SUMMARY

PROPERTY:	84 Centenary Drive, Strathfield Lots 300 and 301 in DP 1208910
DA NO.:	2015/100
APPLICATION TYPE:	Demolition, tree removal and construction of a staged development containing two (2) apartment buildings and townhouses, internal roads and landscaping.
REPORT BY:	Kerry Gordon – Consultant Town Planner
RECOMMENDATION:	REFUSAL
SUBMISSIONS:	Total of six (6) submissions were received: four (4) to the initial notification and two (2) to the notification of amended plans.
ZONING:	B4 Mixed Use and part R3 – Medium Density Residential
DATE APPLICATION LODGED:	28 August 2015
APPLICANT:	Alceon Group Pty Ltd – C/- Metro Property Group
OWNER:	Strathfield Golf Club

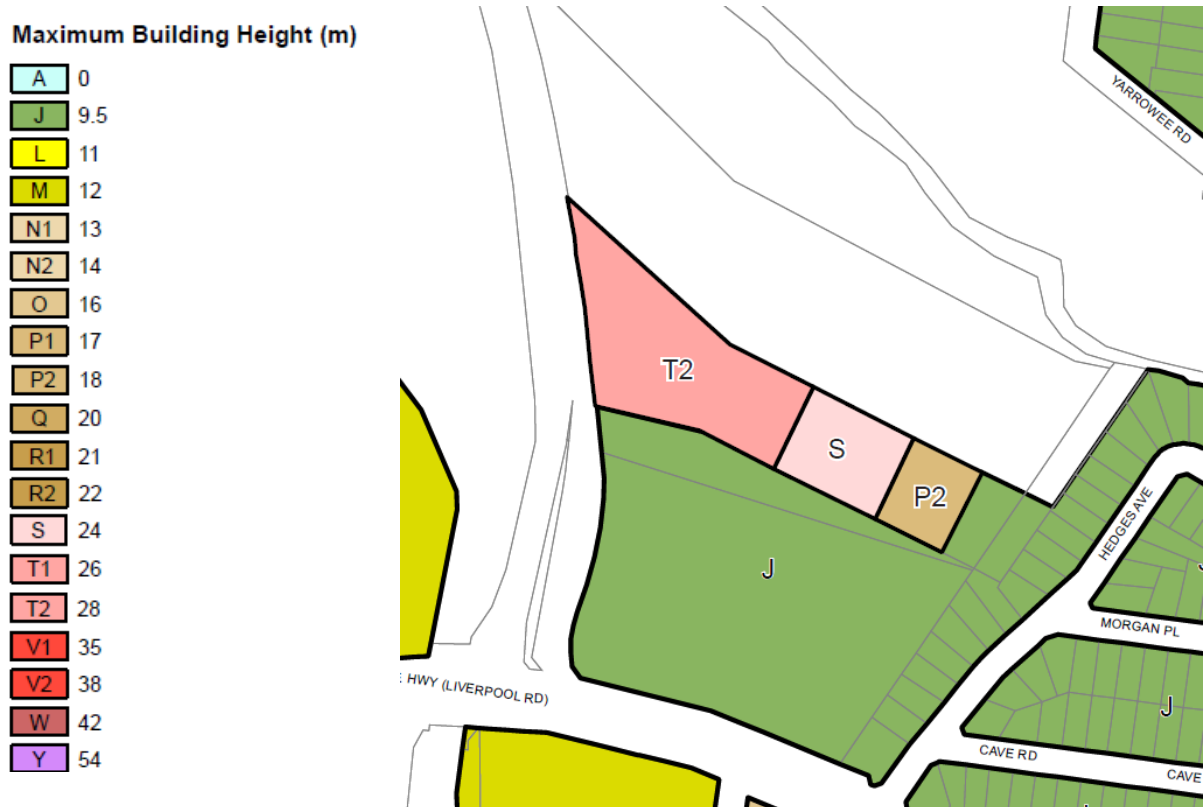
Clause	Required	Proposed	Compliance
4.1A Minimum Site Area: Residential Flat Building	1,000m ²	20,267.9m ²	Yes
4.3 Height of Buildings	28m, 24m, 18m and 9.5m from Centenary Drive frontage to rear of site (see following plan of height controls)	27.41m and 28.07m to top of lift overruns Building A and 28.30m and 28.61m to top of lift overruns Building B 9.38m to top of parapet townhouses	No. Lift overruns breach the control. Yes
4.4 Floor Space Ratio	1.2:1 (max 24,321.5m ²)	24,324m ² , 1.2003:1 (breach by 2.5m ²)	No

The height control provisions for the site can be seen in the following extract from the SLEP 2012 height map.

The applicant has indicated that whilst they are aware of the breaches of the FSR and height control, a clause 4.6 variation request would not be submitted and they have requested a condition requiring compliance with the controls.

It is not considered that such a condition is appropriate, particularly in relation to the height of the lift overruns. Such a condition would effectively require Building B to be lowered by in the order of 600mm which would affect the levels of the basement and other design aspects, such as the levels for accessibility from the street, which is located at a higher level than the site. It is noted that neither of the variations is numerically significant and as such, were a clause 4.6 variation request submitted, it would have a reasonable chance of being successful. This would be the appropriate way of dealing with the variations to the controls. However, as a written request to vary the standards has not been received, development consent is unable to be granted in accordance with Clause 4.6(3).
